040-0785-01

VERTICAL AMPLIFIER MICROCIRCUIT REPLACEMENT

7A26 Serial Numbers B010100 - B139377

MANUAL MODIFICATION INSERT

Fig. 1. Partial - Amplifier circuit board (solder side)

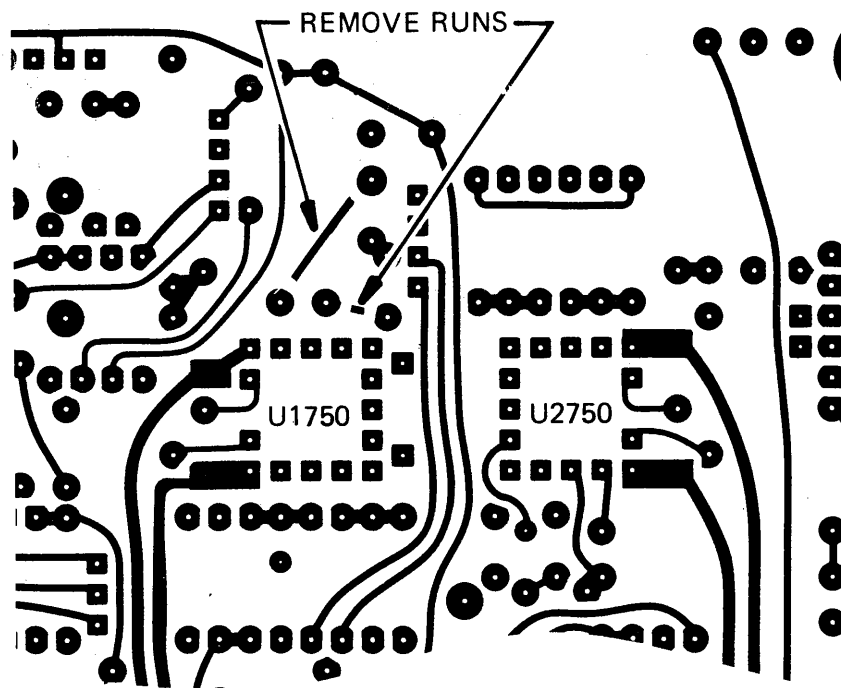
- () 2. Remove the CH1 Readout circuit board (A3) mounting screws - one near the rear and six near the front.
- () 3. Swing the CH1 Readout circuit board out of the way to gain access to the back of the Amplifier circuit board (A2).
- () 4. Amplifiers in the serial number range B050000 to B109999 only: Cut and remove the two runs on the back of the Amplifier circuit board as shown in Fig. 1.

The runs to be removed are located under the CH1 VARIABLE (CAL IN)/ GAIN potentiometer-switch combination. Removal of the combination will facilitate access to the circuit board runs.

Fig. 2. Partial - Amplifier circuit board (component side)

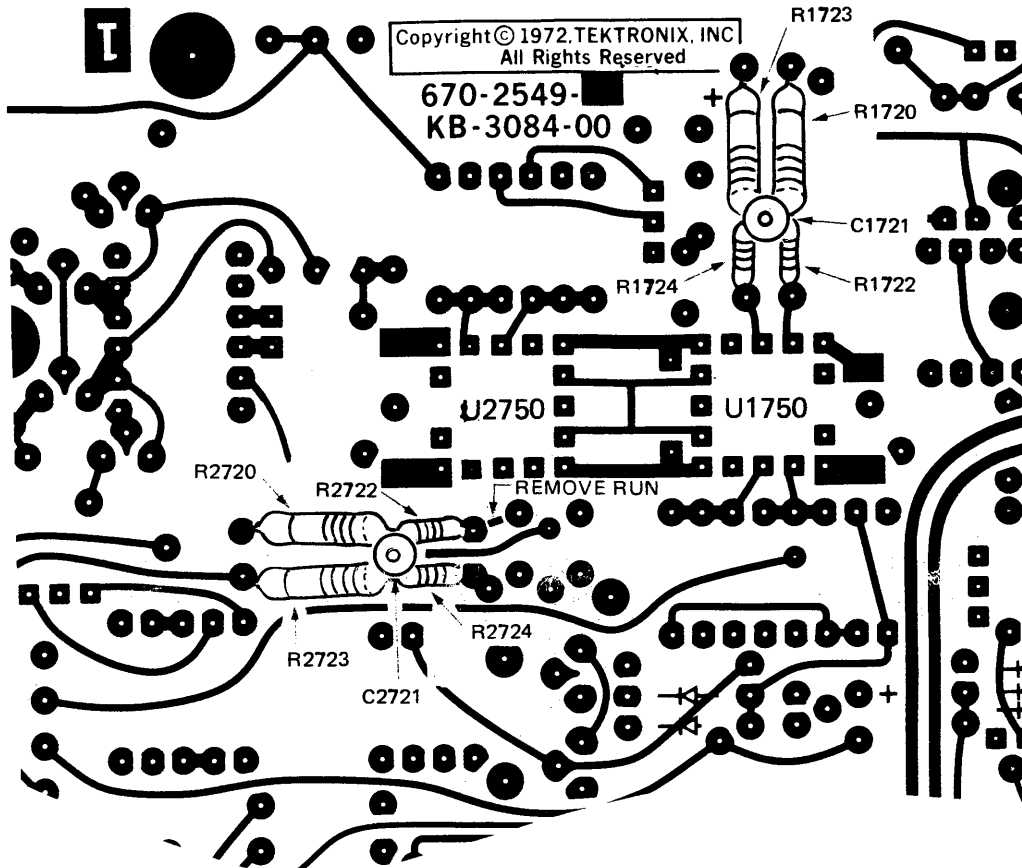
For steps 6 through 15, refer to Fig. 2.

- () 6. On the front (component) side of the Amplifier circuit board, cut and remove the run between C2721, a 5-25pF variable capacitor, and R2721, a 27 Ω , 0.25W resistor.

- () 7. Remove C2721 and R2721.
- () 8. Remove C1721, a 5-25pF variable capacitor, and R1721, a 25 Ω , 0.25W resistor, located near U1750.
- () 9. Unsolder and lift the ends of R1720 and R1723 (both 1.37k Ω resistors) which connect to pin 2 and 3, respectively, of U1750.

- () 10. Trim the leads of the four 15 Ω resistors, included in the kit, to about 3/16 (0.1875) inch.
- () 11. Add R1722 and R1724, two of the 15 Ω resistors, in series between the lifted ends of R1720/R1723 and the circuit board pads from which the ends were lifted.

- () 12. Add C1721, one of the 5-25pF variable capacitors included in the kit, between the junctions of R1720/R1722 and R1723/R1724.
- () 13. Unsolder and lift the ends of R2720 and R2723 (both 1.3k Ω) nearest U2750.

- () 14. Add R2722 and R2724, the two remaining 15 Ω resistors, in series between the lifted ends of R2720 and R2723 and the circuit board pads from which the resistors were lifted.

- () 15. Add C2721, the remaining 5-25pF variable capacitor, between the junctions of R2720/R2722 and R2723/R2724.
- () 16. Replace the faulty amplifier microcircuit (U1350, U1450, U1550, U1750, U2350, U2450, U2550 or U2750) with the microcircuit provided in the kit.

Partial - CH1 AMPLIFIER schematic

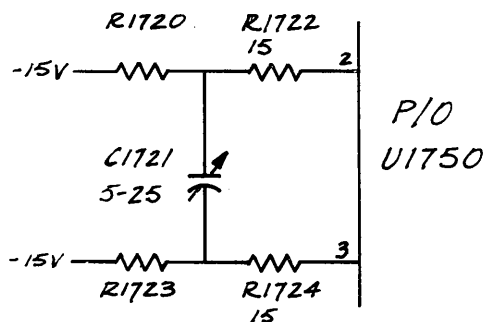
CKT. NO.	PART NUMBER	DESCRIPTION
C1721	281-0123-00	Capacitor, var. cer. 5-25pF 100V
C2721	281-0123-00	Capacitor, var. cer. 5-25pF 100V
R1721	DELETE	
R1722	315-0150-00	Resistor, cmprsn. 15Ω 5% 0.25W
R1724	315-0150-00	Resistor, cmprsn. 15Ω 5% 0.25W
R2721	DELETE	
R2722	315-0150-00	Resistor, cmprsn. 15Ω 5% 0.25W
R2724	315-0150-00	Resistor, cmprsn. 15Ω 5% 0.25W
*	155-0078-10	Microcircuit, linear, vertical amplifier

A similar schematic applies to channel 2. The first digit in each circuit number changes to 2, e.g. C2721.
